Subject: Division Order to Address Mine Water Discharge and Provide Adequate Bonding, Genwal Resources, Inc., Crandall Canyon Mine, C/015/0032-DO10A, Outgoing File

<u>PERMITTEE</u>	ORDER & FINDINGS OF PERMIT DEFICIENCY/INADEQUATE BONDING
David Hibbs, President Genwal Resources, Inc. P.O. Box 910 Price, Utah 84520-0910	
PERMIT NUMBER <u>C/015/0032</u> DIVISION NUMBER <u>DO10A</u>

Hydrologic Evaluation of the Crandall Canyon Mine Discharge

Figure 3. Plots Showing Selected Crandall Canyon Mine Water Discharge Monitoring Parameters, 1995 – Present

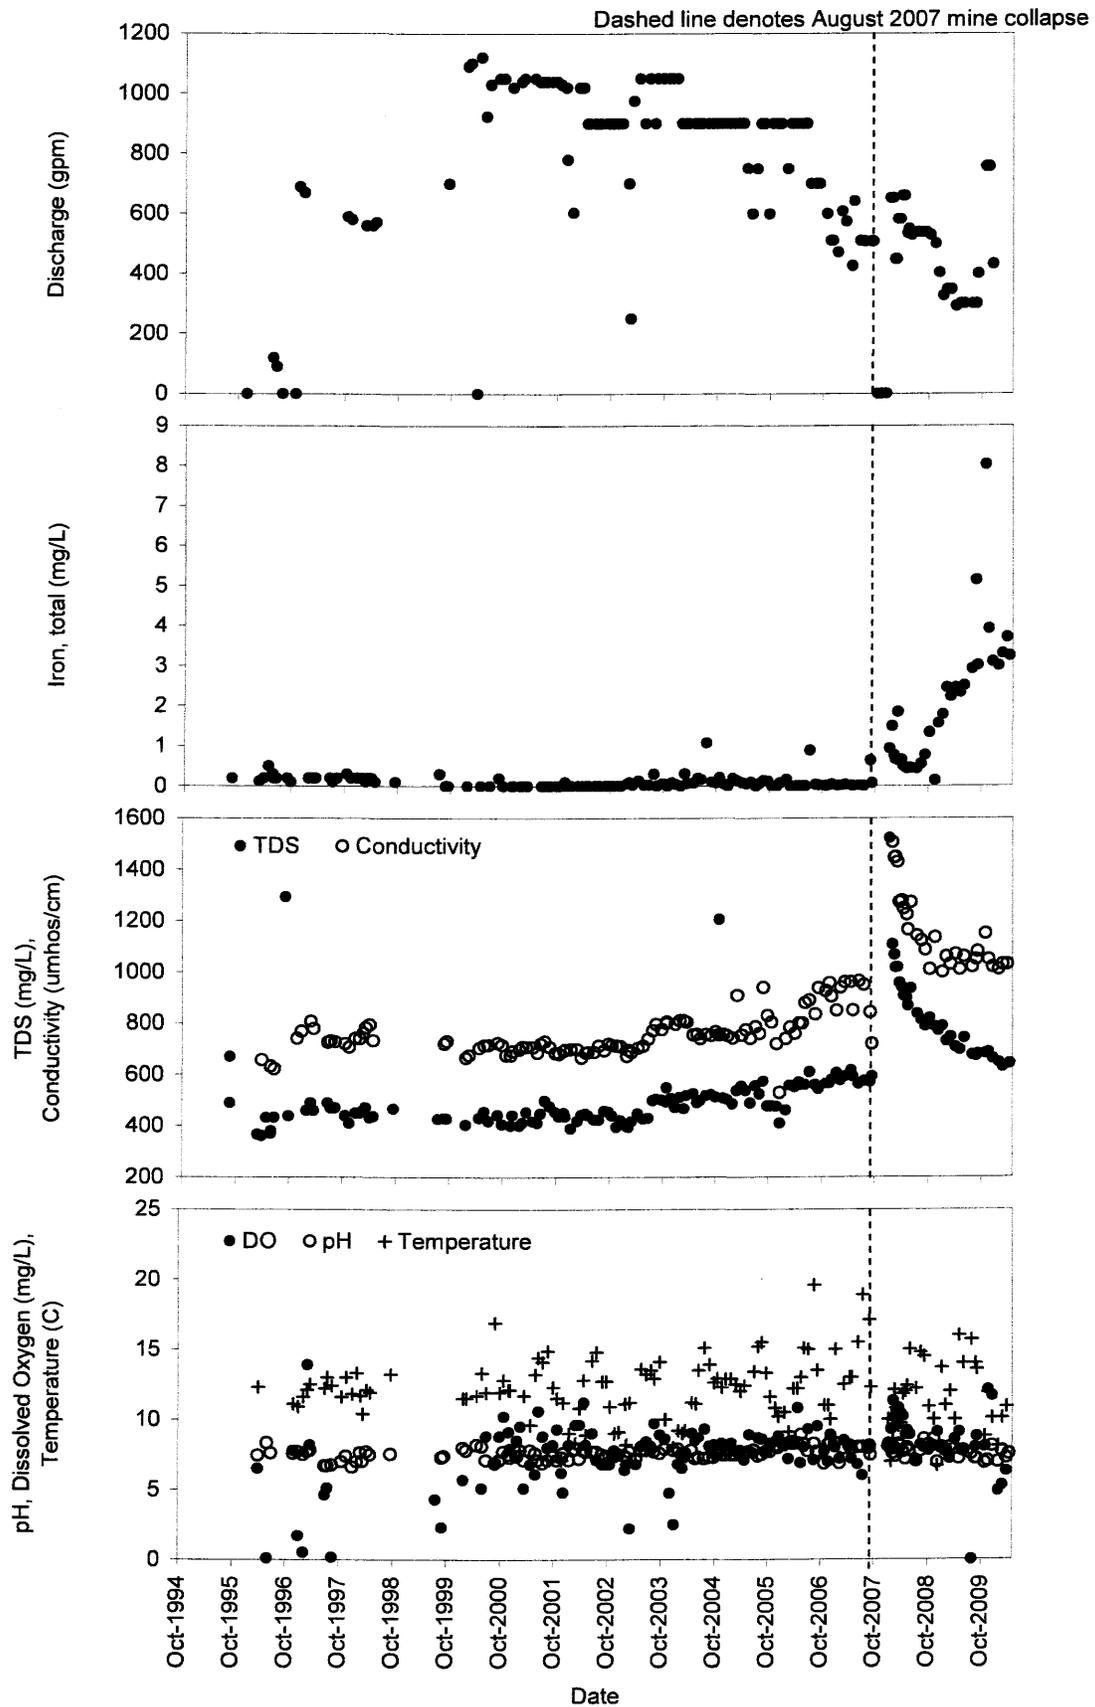
The flow data shown in Figure 3 do not illustrate a trend or seasonal variability in flow rates from the mine. The operator has reported that since the 2007 collapse, mine flow rates fluctuate as a function of barometric pressure and/or air temperature changes. The absence of a continuous monitoring record of mine discharge rate to date prevent the validation of these observations. An electronic flow meter (Grayline AVFM-100 area-velocity flow meter) capable of supporting a data logger and telemetry was installed by the operator during 1st quarter 2010. It is hoped that a continuous or daily flow record will be obtained from the new flow meter, which will improve the understanding of flow characteristics and which may enable correlation between flow and weather conditions.

Figure 5. Plots Showing Water Quality Data from Crandall Canyon Mine and Skyline Mine CS-14

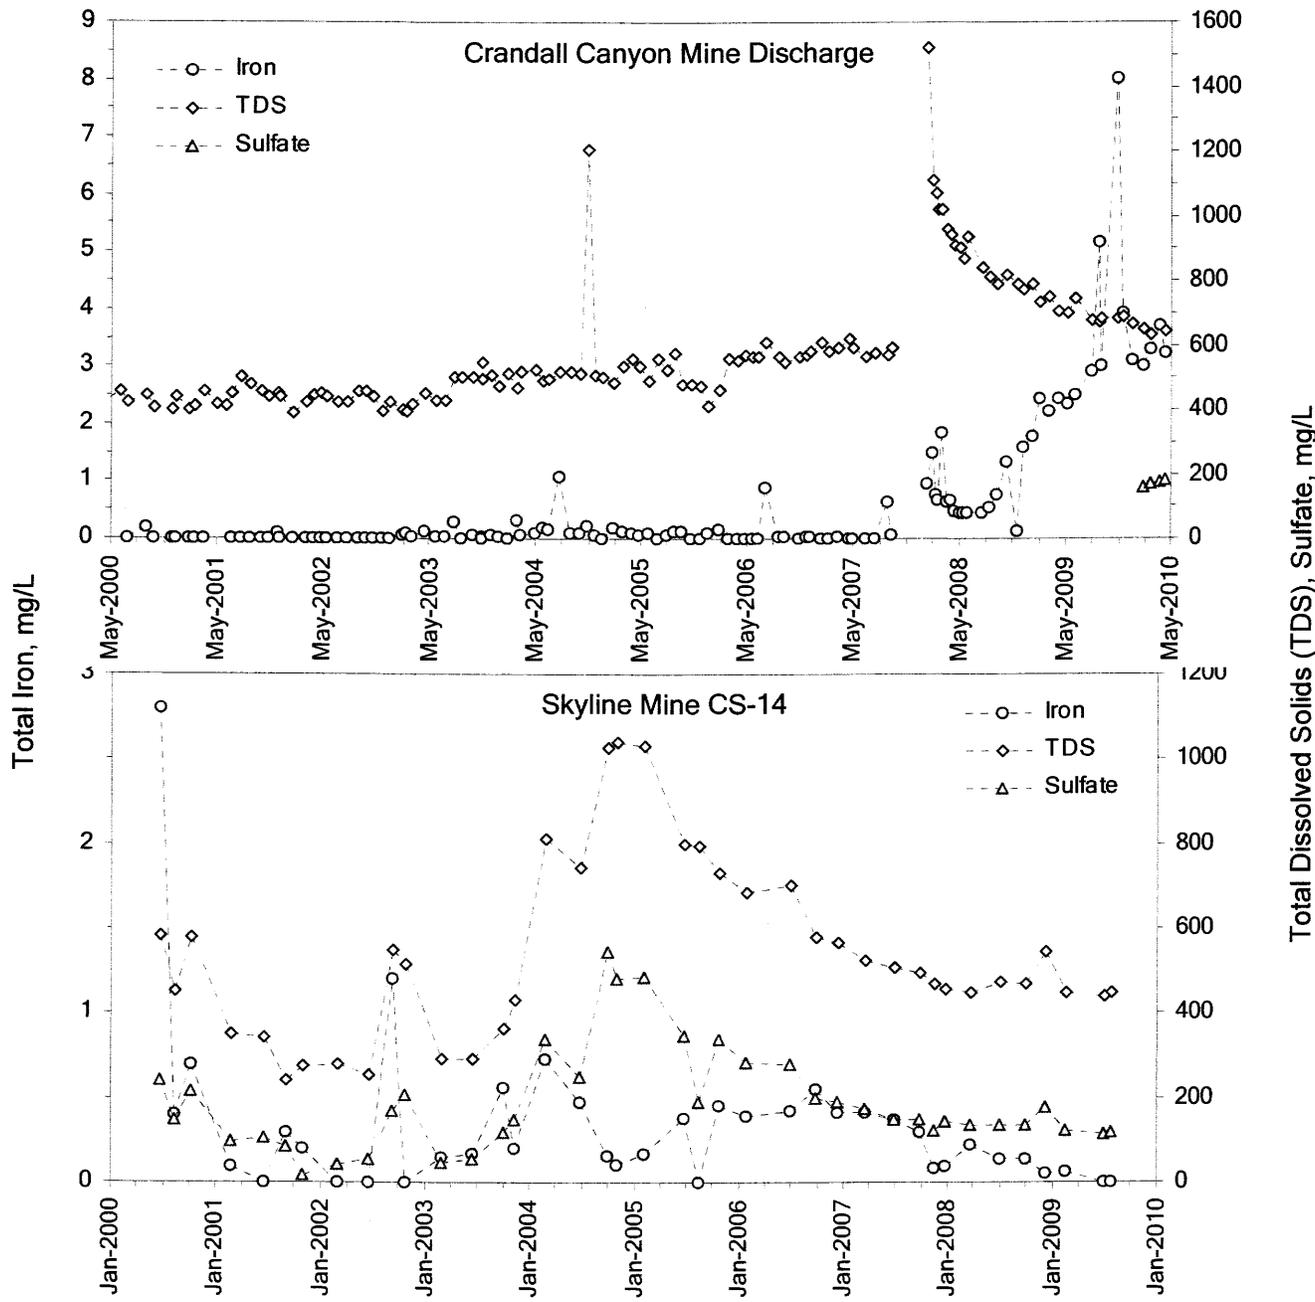
- The Skyline discharge and its elevated iron concentrations were not brought about due to a catastrophic mine collapse, but were the result of a planned flooding of a mined-out area.
- Plots of water quality data from the Crandall Canyon Mine discharge and Skyline Mine CS-14 show noticeably different trends and magnitudes for TDS and total iron concentrations (Figure 5). The 2010 Petersen Hydrologic report does not offer an explanation of the variation in TDS and total iron concentrations and trends exhibited at the Skyline Mine compared to Crandall Canyon Mine.

Petersen Hydrologic's assertion that there is a finite amount of reactants within the mine and that the total iron concentrations will begin to decline within a few years as the pyrite minerals are consumed through oxidation processes may very well be correct. However, asserting that the process will "likely occur within a few years" is problematic due to several unknown variables:
